SITE INSTRUCTION

SI A14

PROJECT : **Forestside**
PROJECT # : 1331.15
DATE : Dec. 06, 2021

Title: Revisions to plans as itemized.

BUILDING SECTION 4
1:50 A501

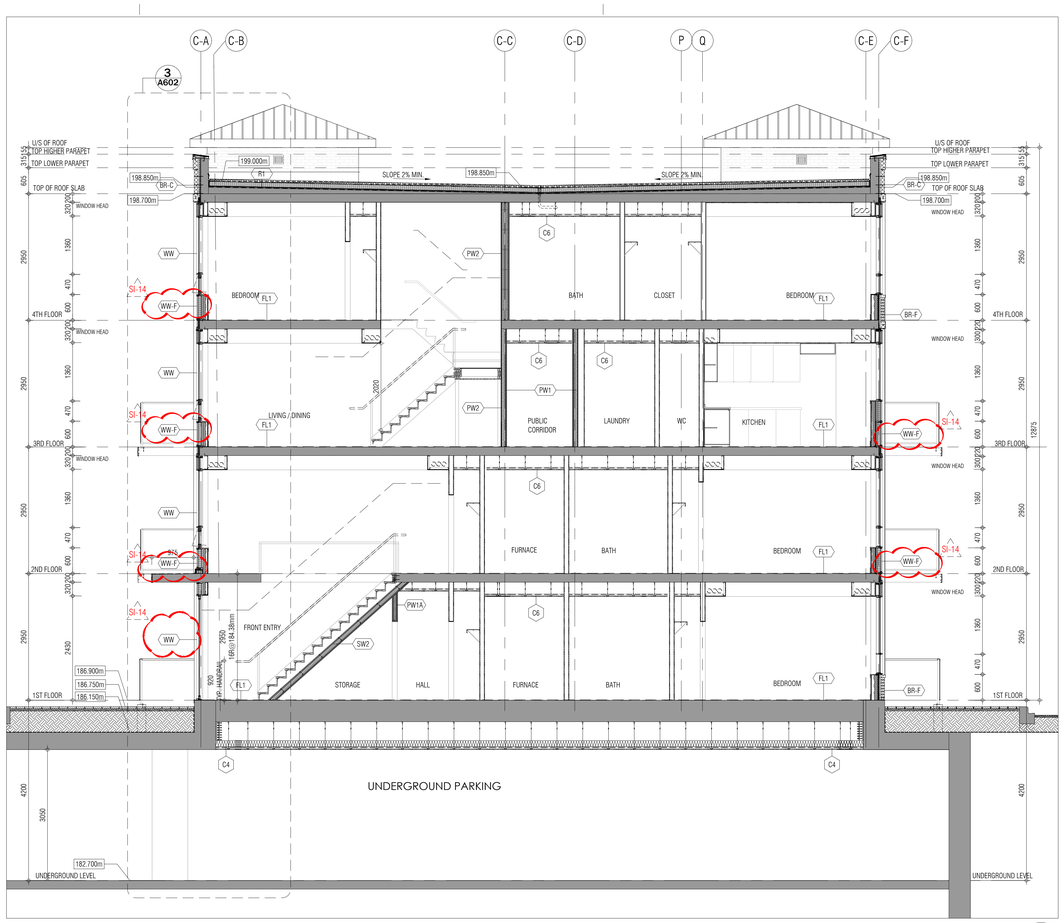
2/A501	Building Section	• Flipped section to match plan section marker view. • Revise window wall tags and move wall section back to original location.
3/501	Building Section	• Indicate PW2 wall tag to fourth floor.
4/501	Building Section	• Revise window wall tag.
1-2/502	Building Section	• Indicate and Updated stairs from second floor unit above at ramp to poured concrete walls and stairs with insulation and revise spot elevations. • Updated section views of walls, railings of unit and stairs beyond. • Updated grid tag indications. • Revised window wall tag.
2/A503	Building Section	• Show roof access hatch and ladder beyond. • Add top of concrete wall spot elevation at elevator parapet walls. • Update wall tags at elevator walls. • Rotated Grid tags.

BUILDING SECTION 1 / A504 — 1:50

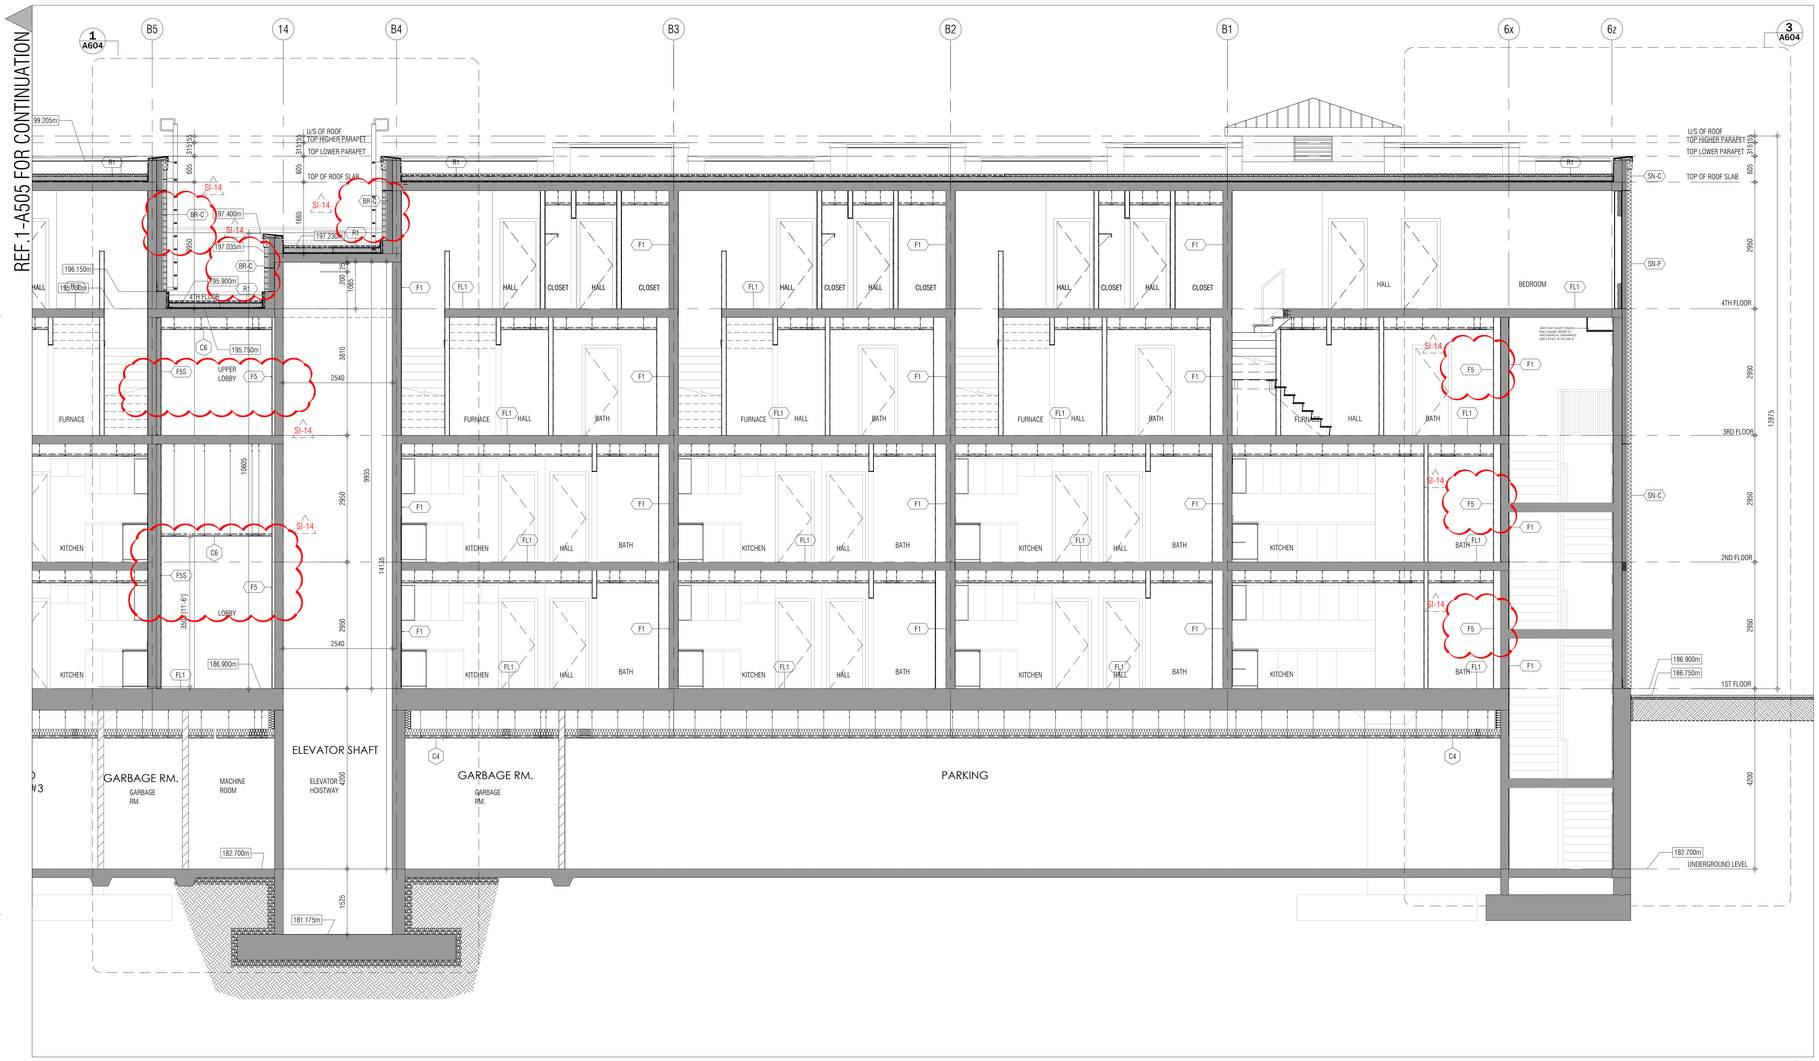
1/A504	Building Sections	• Add wall tags at suite and elevator walls. • Add wall tags at stair and suite walls.
1a/A504	Building Sections	• Show spray foam insulation at ext. walls. • Add wall tags at stair and suite walls. • Update window wall.
1/505	Building Sections	• Updated exterior walls and tags. • Updated exterior wall at link and suite revised wall tags.
3/A505	Building Sections	• Updated exterior wall tags at link building. Revised mechanical room to void space.
3/A506	Building Section	• New building section 3/A506 at stairs from second floor unit 239 at ramp in building C.
A601	Wall Sections	• Updated exterior wall tags. • Updated Grid tag indications. • Added Firestop Note.
A602	Wall Sections	• Flipped section 4/A602 to match plan section marker view. • Updated exterior wall tags. • Updated Grid tag indications • Added Firestop Note.
A603	Wall Sections	• Updated exterior wall tags. • Updated Grid tag indications. • Added Firestop note.

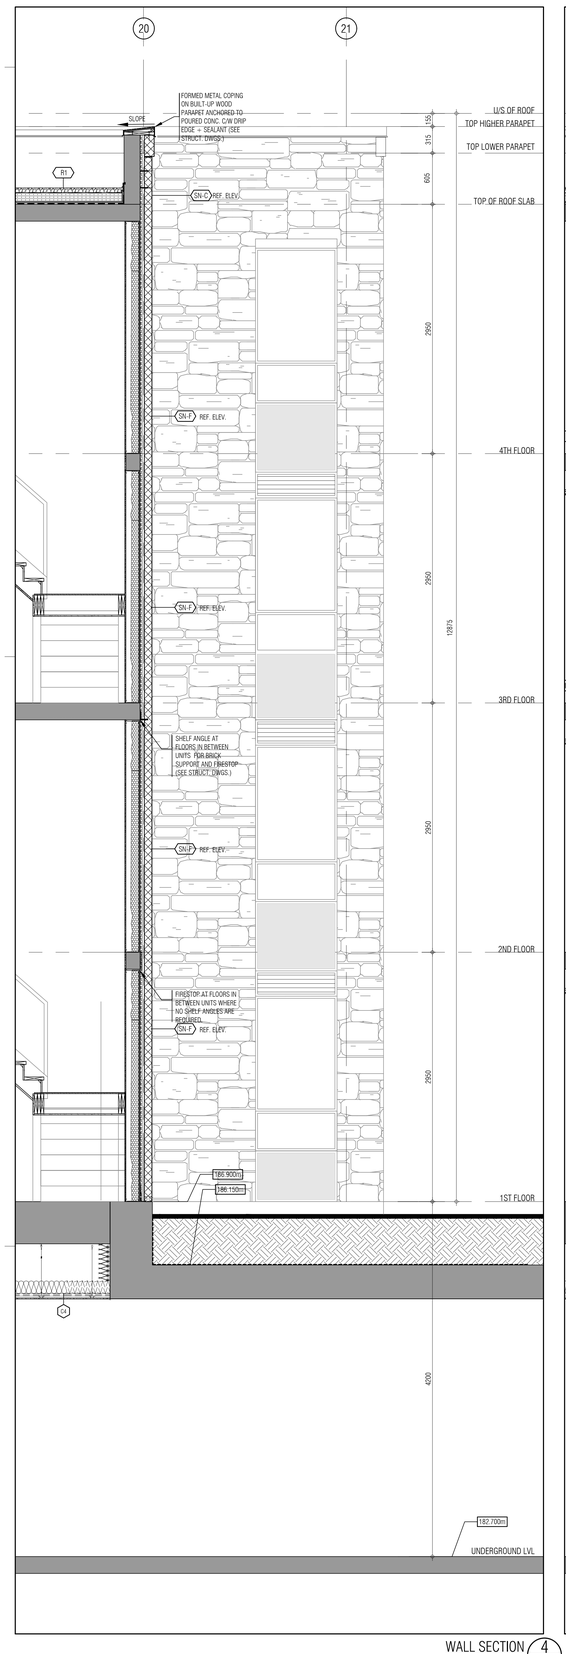
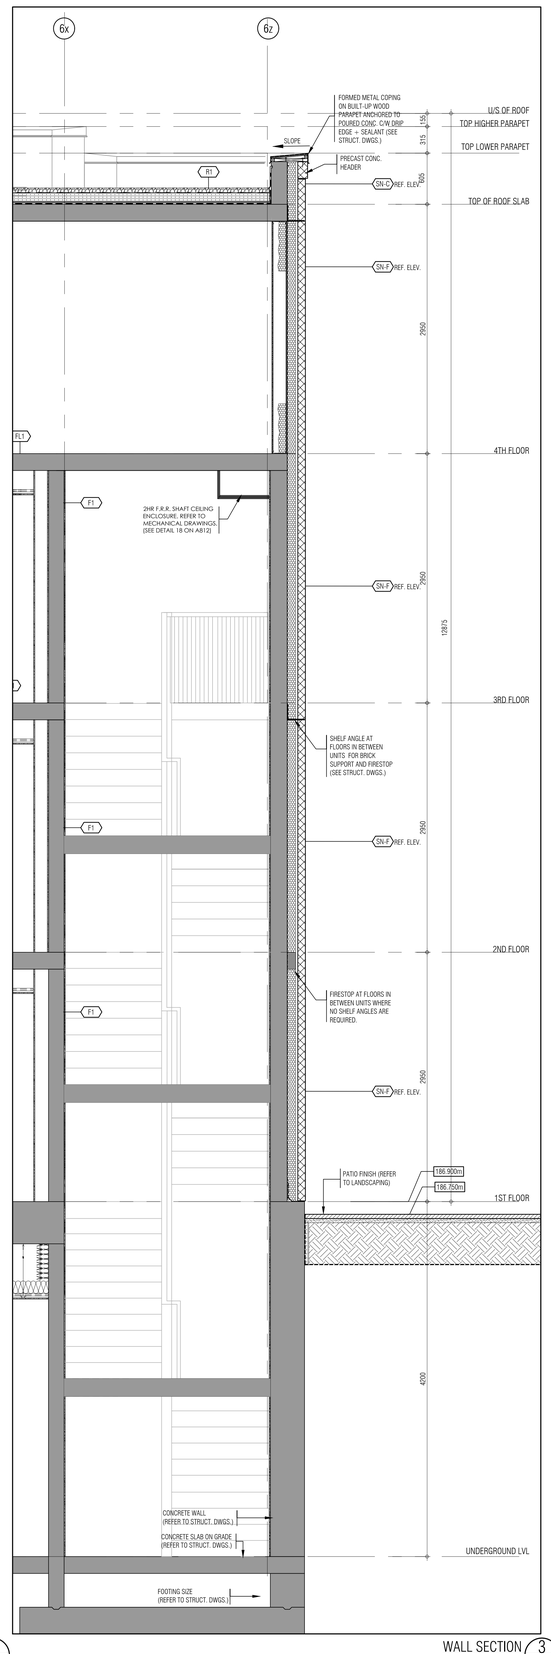
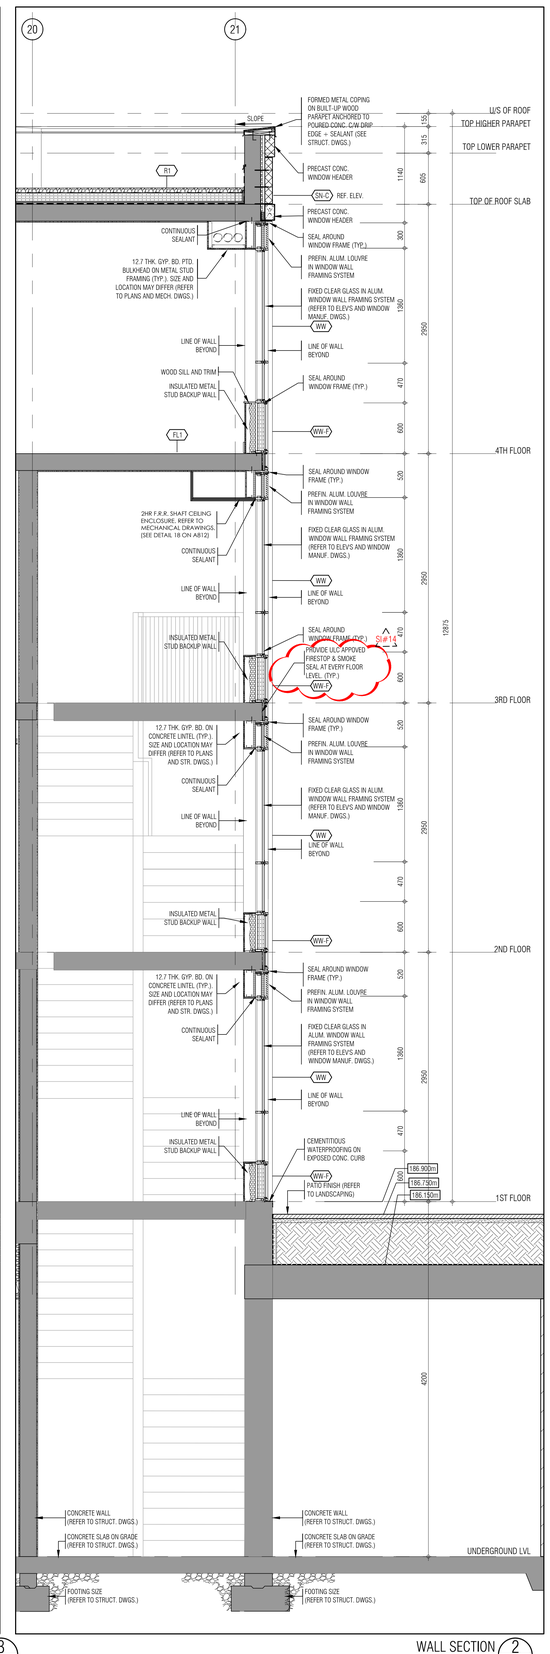
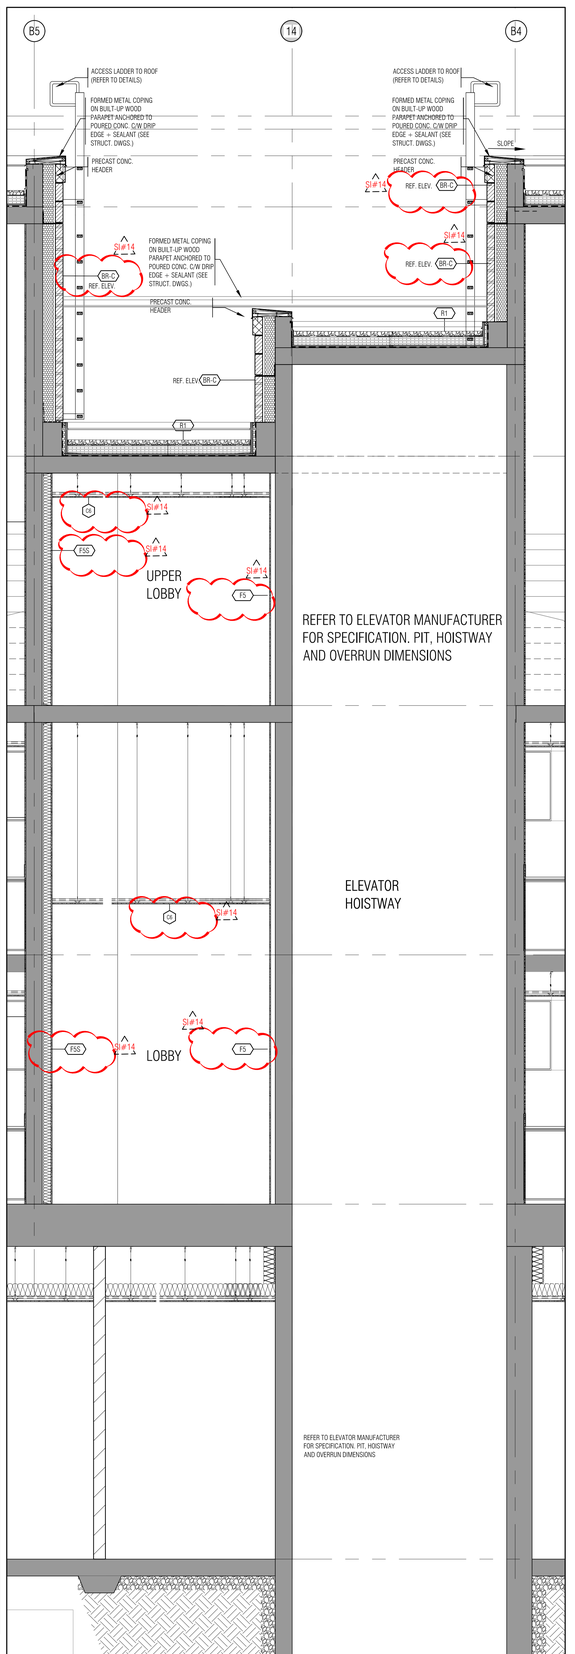
A604	Wall Sections	• Updated exterior wall tags. • Added Firestop Note.
